1 UNITED STATES OF AMERICA
2 NUCLEAR REGULATORY COMMISSION
3 BEFORE THE ATOMIC SAFETY AND LICENSING BOARD
4

5 In the Matter of)
6)
7 STRATA ENERGY, INC.,) Docket No. 40-9091-MLA
8)
9 (Ross *In Situ* Recovery Uranium Project))
10
11
12

13 Pre-Filed Direct Testimony of Dr. Richard Abitz
14 Supporting Joint Intervenors' Contentions 1 and 3
15

- 1 Pourbaix diagrams displaying relevant geochemical conditions from Geochemist
- 2 Workbench®. Top figure shows Iron and bottom figure shows the uranium stability fields.
- 3

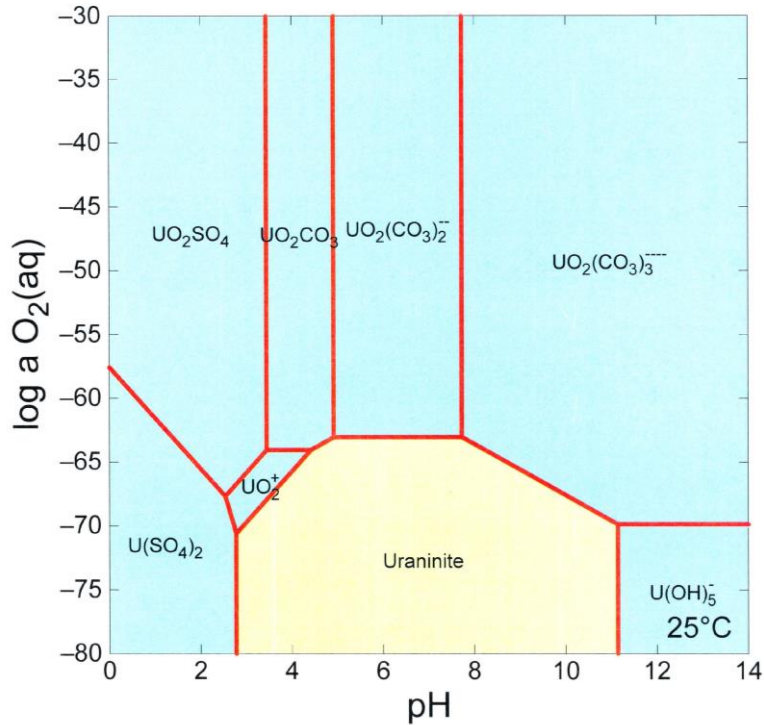
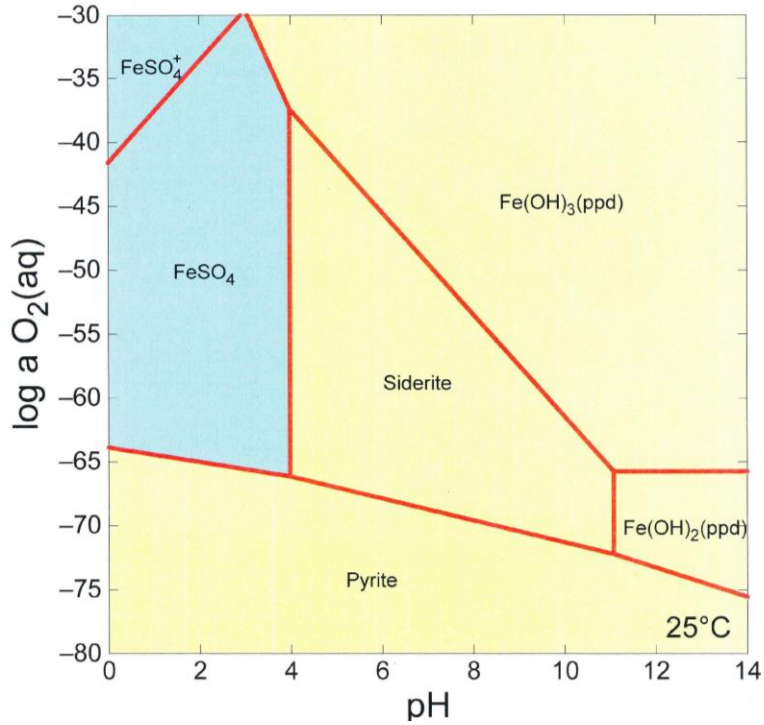
1 commercial software, such as the Geochemist's Workbench (<http://www.gwb.com/>). I
2 calculated the stability field for pyrite (below figure) using the Geochemist's Workbench and the
3 approximate highest groundwater concentrations for iron (0.57 milligrams/liter), carbonate (610
4 milligrams/liter) and sulfate (920 milligrams/liter), as reported for the ore zone (Appendix C of
5 FSEIS). The thermodynamic calculations indicate that pyrite is stable over the pH range of 6 to
6 10 only when oxygen levels are below 1×10^{-65} moles/liter. Next, the uranium concentration in
7 groundwater can be estimated by constraining the uraninite stability field to oxygen levels less
8 than about 1×10^{-65} moles/liter. I constructed this figure (below) using the same water quality data
9 noted above and when the uraninite stability field is below oxygen levels of 1×10^{-65} moles/liter,
10 uranium concentrations in groundwater are less than 1×10^{-10} moles/liter (2.38E-08 grams/liter or

11 2.38E-14 micrograms liter, which is over 13 orders of magnitude lower than the EPA uranium
12 MCL of 30 micrograms/liter). This analysis shows that the true uranium concentration in
13 groundwater contacting uraninite and pyrite is so low that it cannot be detected with present
14 laboratory methods.

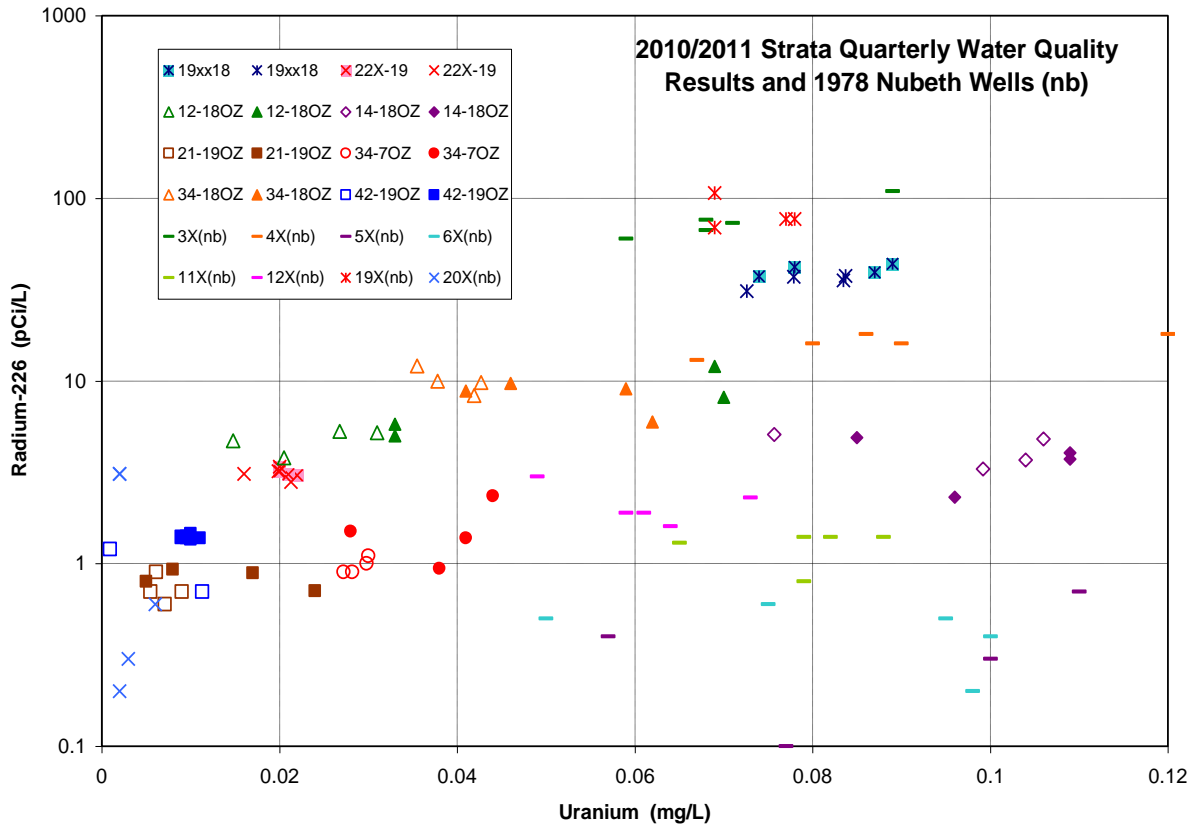
14 In Appendix C of the FSEIS, the 2011 data are tabulated and it is a fundamental failure of
15 the analysis in the FSEIS that it nowhere confronts the significance of the 2011 results relative to
16 the 2010 values. I have plotted the 2011 and 2010 radium-226 and uranium results (below
17 figure) reported in Appendix C and the Nubeth 'baseline' data to reveal the trends that support
18 our conclusions on the anthropogenic degradation of water-quality parameters from mechanical
19 and chemical disturbance of the ore zone during drilling operations and well development before
20 the license has been issued. I will discuss the Strata wells first and refer to the Nubeth wells later
21 in this testimony.

1 The 2011 ore-zone data for Strata's six regional wells (open symbols on the figure) show
2 uranium has decreased in 4 of the 6 wells (12-18, 21-19, 34-07, 34-18) and radium-226 is
3 essentially unchanged, relative to the 2010 data (filled symbols). Uranium decreases over this
4 time interval as the aquifer begins to return to reducing conditions following the initial
5 disturbance and oxidation of the uranium ore when the wells were installed and developed.
6 Radium-226 remains at the 2010 levels as radium is insensitive to redox changes once it is
7 released from the uranium bearing ore. The initial magnitude of disturbance and oxidation of the
8 uranium ore varies from location to location, as it is dependent on the time spent in developing
9 the well with air lift and jetting techniques. For well 14-18, the similar results for 2010 and 2011
10 indicate the ore zone may have been disturbed for a longer period of time during well

11 development. Importantly, the trends for uranium and radium-226 show that the ore zone is
12 disturbed and oxidized by well installation and development activities and it is inaccurate of the
13 NRC Staff to assert that a true baseline can be developed after hundreds to thousands of wells are

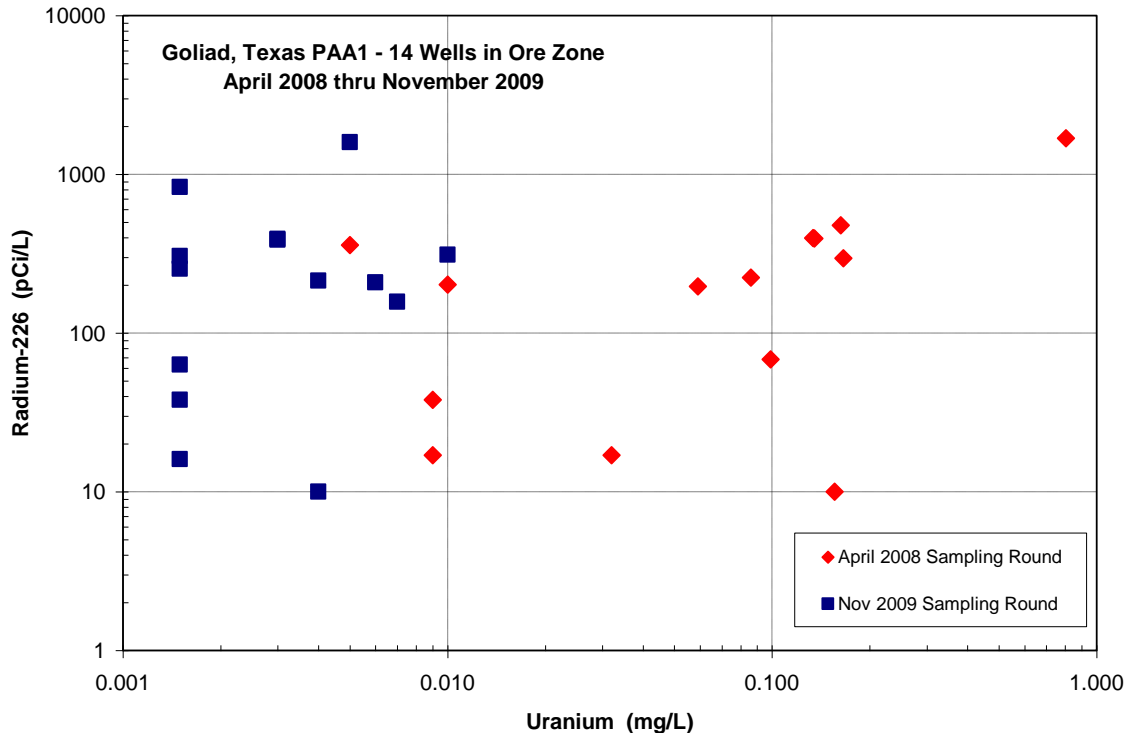
11 Table 5.2 and JTI016, 2009 updates). Again I plotted the uranium and radium results for the site

1 (see figure on next page). Installation of the production wells was performed with improper
2 methods and anthropogenic oxidation of the ore body was captured by the first sampling round
3 in April through September of 2008 (red diamonds in below figure). Fourteen months later,
4 another sampling round was collected in November 2009 for the same wells and all uranium
5 levels had fallen below the EPA uranium MCL of 0.03 mg/L (blue squares); most decreasing by
6 at least an order of magnitude. Again, once the ore body is oxidized during well installation, the
7 radium-226 released from the uranium ore will not drop out of solution because it is insensitive
8 to redox changes. Therefore, allowing improper well installation methods results in
9 contamination of the groundwater prior to any mining activity taking place and the ISL industry
10 'baseline' values are invalid for uranium, radium-226 and other contaminants associated with the

¹ Baseline for Kingsville Dome Production Area Authorization (PAA) 1 and PAA 2 were established two years apart and much higher values were measured for PAA2 (invalid average values - PAA1: uranium = 0.164 mg/L; radium-226 = 22 pCi/L. PAA2: uranium = 1.89 mg/L; radium-226 = 92 pCi/L).

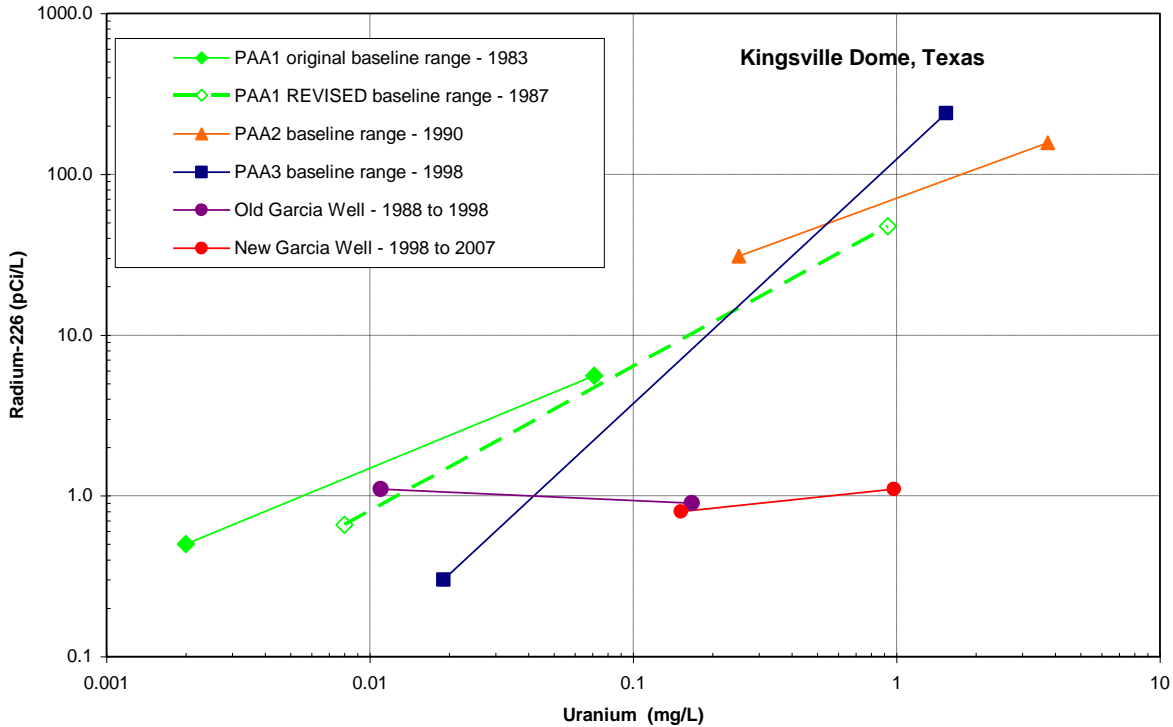
1 allow post-licensing, pre-operational 'baseline' for each well field as it is built. I created a chart
2 that can be found below to illustrate these concerns.

3 In August 1983, the initial PAA1 'baseline' was established after the installation of
4 production wells in the ore zone (JTI019, Table 2.7-4 from URI 1983c), and the ranges for
5 uranium and radium-226 for this invalid 'baseline' are shown by the solid green diamonds and
6 bold green line on the below figure. After additional well fields were built out, the Texas Water
7 Commission (JTI017, TWC 1988, p.10) [TWC is now the Texas Commission on Environmental
8 Quality (TCEQ)] allowed the operator to revise the 'baseline' for PAA1 in November 1987
9 (open green diamonds and fine green line on the figure). In doing so, TWC allowed the operator
10 to increase the 'baseline' for both uranium and radium-226 by using maximum values that were
11 approximately ten times higher relative to the initial 'baseline' established in 1983.

12 In February 1990, after mining at PAA1 for approximately 6.5 years, TWC (JTI018,
13 1990, p.9) allowed the operator to establish 'baseline' values at the adjacent PAA2 (solid orange
14 triangles and orange line on the figure), which is located downgradient from the ISL operations
15 in PAA1. This TCEQ action allowed the operator to elevate the uranium 'baseline' value using a
16 maximum value (3.8 mg/L) that is 100 times higher than the maximum uranium value (0.071
17 mg/L) used to calculate the initial PAA1 'baseline'. Proceeding to PAA3, TWC (JTI020, 2006,
18 p.12) allowed the operator to establish 'baseline' in June of 1998, nearly fifteen years after
19 mining began in PAA1. Therefore, the record at Kingsville Dome clearly shows the
20 deterioration of the nominal invalid 'baseline' values with time when the operator is allowed to
21 develop the 'baseline' for each unit as the well fields are built out.

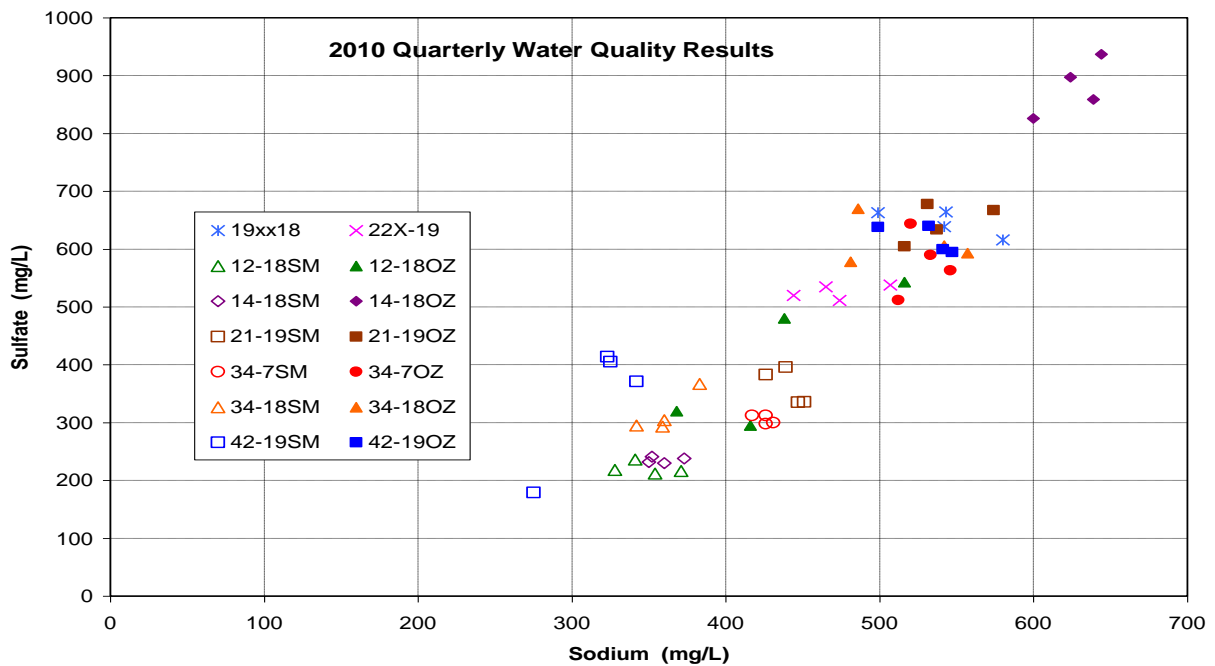
20 A. 44. Demonstration of adequate hydrologic control is not a trivial matter because groundwater
21 communication between the SM and OZ horizons is evident in the 24-hour pump test data from
22 well 12-18OZ and the water-quality results for sodium and sulfate (see my figure below,

1 constructed from data in Appendix C of the FSEIS (SEI009A). Groundwater from the ore
2 horizon (OZ; solid symbols) generally has higher sodium and sulfate, relative to the overlying
3 groundwater (SM). However, mixing of the groundwater from these two horizons is clearly
4 indicated by the linear trace of the sodium and sulfate trend on Figure 2. In my expert opinion,
5 this is unquestionably demonstrated by the mid-location of plotted samples from 22X-19, a well
6 that is screened through the OZ and SM zones (SEI006A, Section 2.7.3.3.1, p.2-169, Strata TR).
7 If 14-18OZ is taken as the unmixed groundwater from the ore horizon, all other OZ samples are
8 shown to have a component of SM water, as they lie between 14-18OZ and 22x-19. Note that
9 the strong mixing between the horizons is unequivocal for samples from 12-18OZ, which plot
10 with the samples from 22x-19 and the SM horizon.

4 A. 45. The above figure illustrates that the closer a pair of samples plots for a given cluster well
5 (e.g., 12-18SM and 12-18OZ), the higher the probability for groundwater contamination by
6 communication between the two groundwater zones during ISL operations. In contrast to mixing
7 between the 12-18 horizons, 14-18SM and 14-18OZ samples cluster tightly and are well
8 separated on the plot. An explanation for the distinct separation of the 14-18 horizons on the
9 sodium-sulfate plot may be that the density of exploration boreholes is lower around this cluster
10 well and less communication between the SM and OZ horizons has occurred (*i.e.*, 14-18 may
11 provide a snapshot of the distinct major-ion chemistry of the horizons prior to the drilling of
12 thousands of exploration boreholes).

Fig. 2.8. Alternate interpretations of the same borehole data.

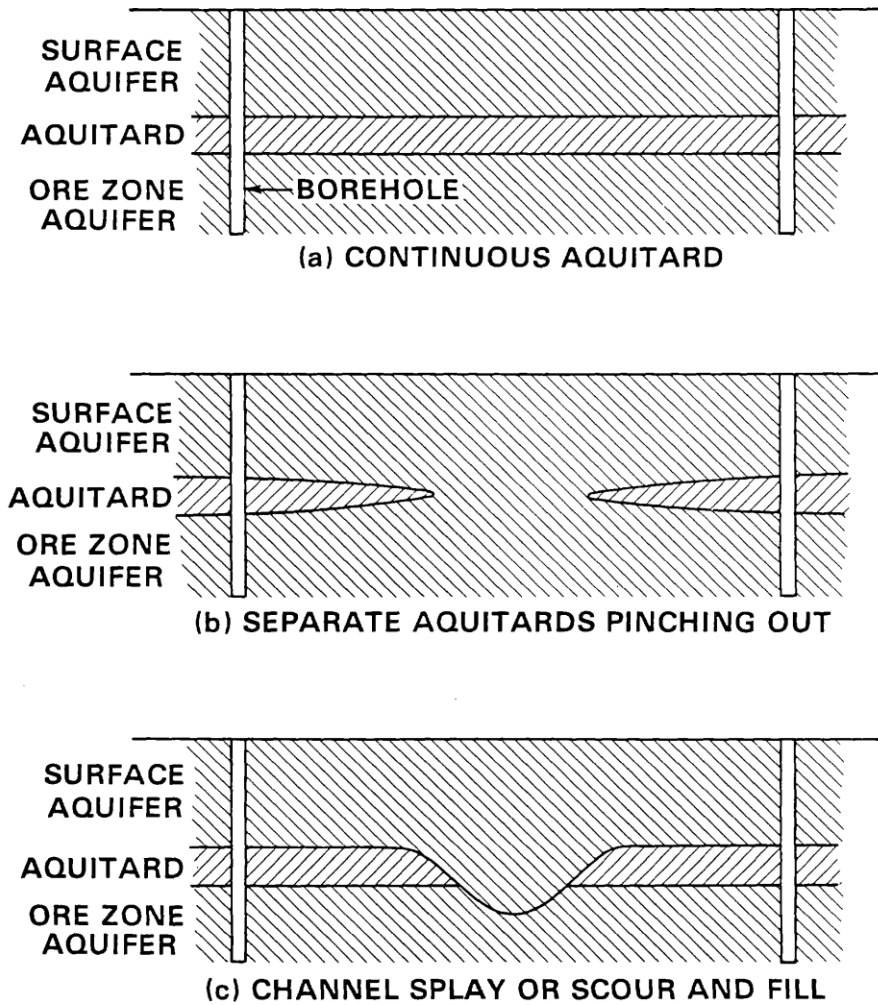
1 A. 46. Yes. The above analysis is supported by the discussion and figure from (Staub et al.1986;
2 NRC020 at p. 24), which provides evidence for alternative interpretations to aquifer tests and the
3 complexities in adequately defining aquifer confinement:

4 *“Conventional exploration methods as describe above seldom*
5 *provide enough detail to determine whether an ore zone aquifer is*
6 *sufficiently isolated from other aquifers. The complex stratigraphy*
7 *of alluvial sediments is a serious obstacle to projection of*
8 *lithologic units between boreholes even at short distances. Figure*
9 *2.8 [original document; see below] presents several*
10 *interpretations of the same data. In the absence of proof of the*
11 *contrary, stratigraphic units are often projected as continuous*
12 *layers between boreholes which may lead to a false sense of*
13 *security with respect to aquifer isolation. Furthermore, two-*
14 *dimensional cross-sections do not necessarily portray accurate*
15 *relationships between aquifers in three dimensions. Thus, an*
16 *aquitard may be continuous in one direction and discontinuous in*
17 *another.” (Staub et al. 1986) (page 24).*
